15.7 Radioactive Release from Subsystems and Components

The information in this section of the reference ABWR DCD, including all subsections, figures and tables, is incorporated by reference with the following departure and supplements.

STD DEP T1 2.15-1

STD DEP 11.3-1 (Figure 15.7-2)

Figure 15.7-2 Offgas System (See Subsection 11.3)

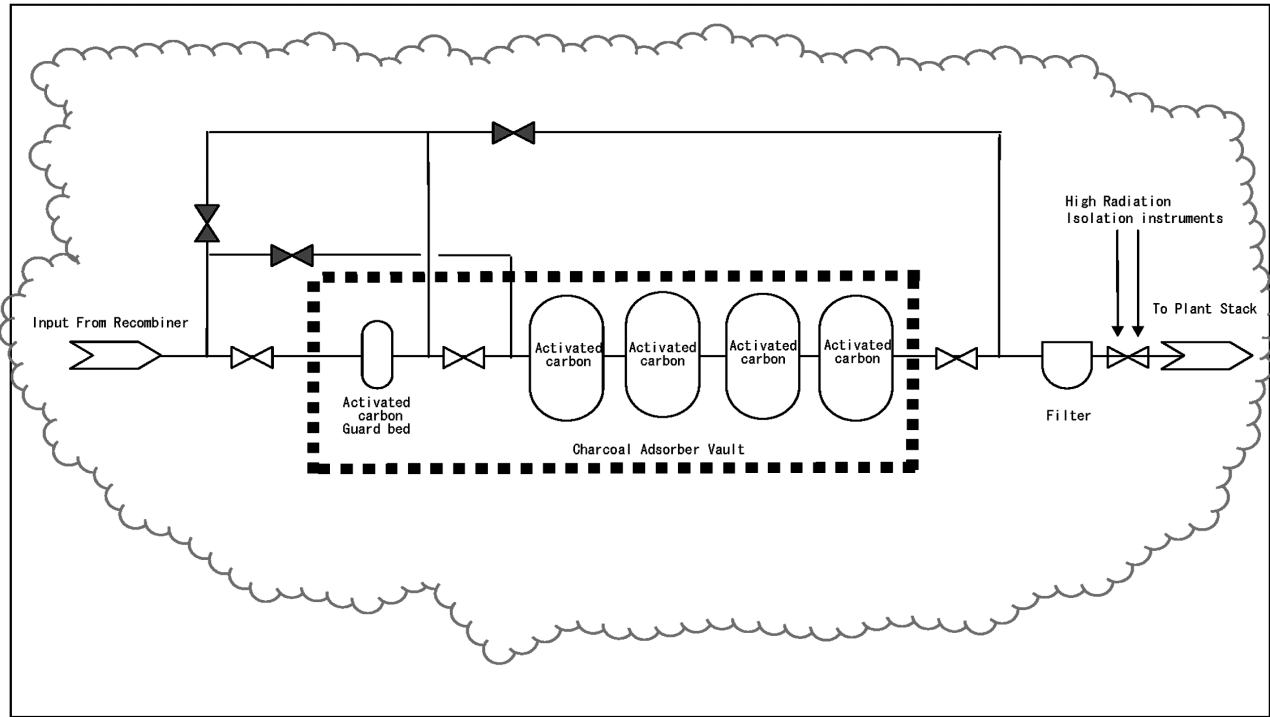
To evaluate the potential radiological consequences of an inadvertent bypass of the charcoal beds, it was assumed that operator error or computer error has led to the bypass of the ~~eight~~four follow-on beds in addition to the failure of the automated air operated downstream isolation valve. It is also assumed that during this period, the plant is running at and continues to run at the maximum permissible offgas rate of 14.8 GBq/s (based upon the assumption of 0.0037 GBq/s/MWt as stipulated in Standard Review Plan 11.3) evaluated to a decay time of 30 minutes from the vessel exit nozzle. Even with the failure of the downstream isolation valve, it is not anticipated or assumed that the isolation instrumentation would fail but would instead

- (1) Flow is through a single 4,721 kg charcoal tank with an evaluated hold up time given by NUREG-0016, equation 1.5.1.6 using K_d 's for Kr and Xe from NUREG-0016.
- (2) ~~An isolation valve prevents flow through the~~ ~~There is no motive force to~~ ~~remove any significant inventory from the eight~~ follow-on charcoal tanks while in bypass and therefore no activity from these tanks is included in the final release calculations.
